Work Order ID 124542

Item Name: Crosstube Turning Detail

| DE APPR. | RF | DRAWING NO. REV. F D407-667-245 SHEET 1 OF 4 TITLE SCALE CROSSTUBE ASS'Y (407 HIGH AFT) NTS | |

| DRAWING NO. D407-667-245 | TITLE CROSSTUBE ASSY (407 HIGH AFT) | REV. F | DART AEROSPACE LTD ENGINEERING ORDER | | D.E.O. NO. D407-667-245-F-1 | SHEET NO. SHEET 1 OF 2 | SCALE NTS |

| DRAWING NO. D407-667-245 | TITLE CROSSTUBE ASSY (407 HIGH AFT) | REV. F | DART AEROSPACE LTD ENGINEERING ORDER | D.E.O. NO. D407-667-245-F-1 | SHEET NO. SHEET 2 OF 2 | SCALE NTS |

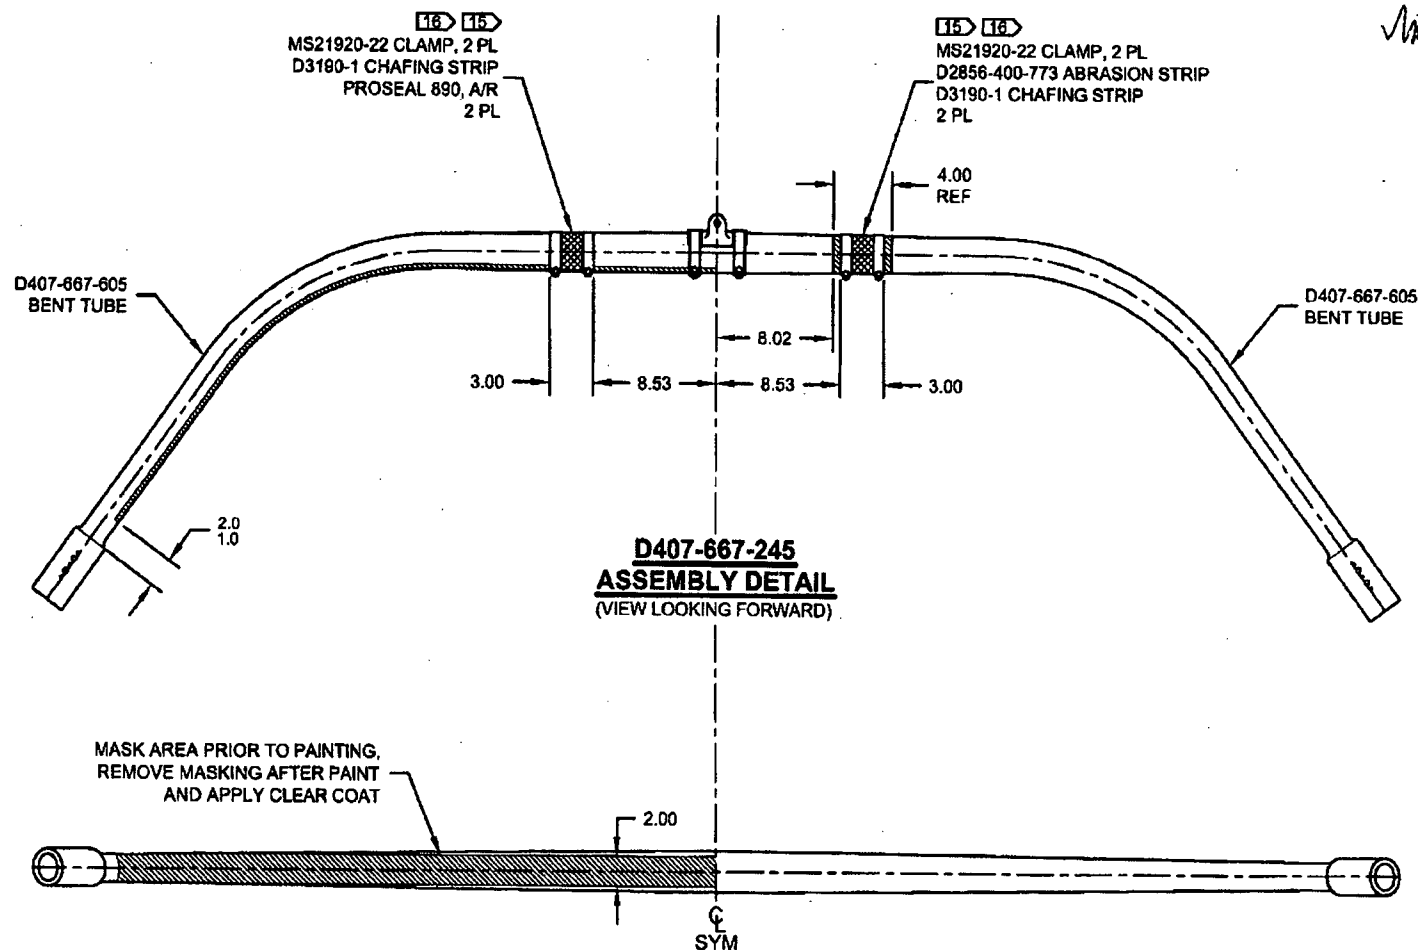
REMOVED ABRASION STRIP IN FAVOR OF A THIN LAYER OF PROSEAL 890.

- 2) FINISH: CHEMICAL CONVERSION COAT PER DART QSI 005 4.1
PRIME INSIDE AND OUTSIDE PER DART QSI 005 4.2
MASK UNDERSIDE OF CROSSTUBE AS SHOWN (HATCHED AREA) AND
PAINT OUTSIDE PER DART QSI 005 4.2
REMOVE MASKING AND APPLY CLEAR COAT
- 15) APPLY A THIN COAT OF PROSEAL 890 ON INSIDE CONCAVE SURFACE OF D3190-1
CHAFING SHIELDS AND LET CURE PER MANUFACTURER'S INSTRUCTIONS. INSTALL
PROSEALED D3190-1 CHAFING SHIELDS ONTO CROSSTUBE BY APPLYING A THIN COAT
OF PROSEAL 890 ONTO CROSSTUBE. BE SURE TO ELIMINATE ANY AIR GAPS.

- 2) FINISH: CHEMICAL CONVERSION COAT PER DART QSI 005 4.1
PRIME INSIDE AND OUTSIDE PER DART QSI 005 4.2
PAINT OUTSIDE PER DART QSI 005 4.2
- 15) INSTALL D2856-400-773 ABRASION STRIP WITH A 0.13 REF GAP ON BOTTOM SIDE OF
CROSSTUBE PER QSI 035.
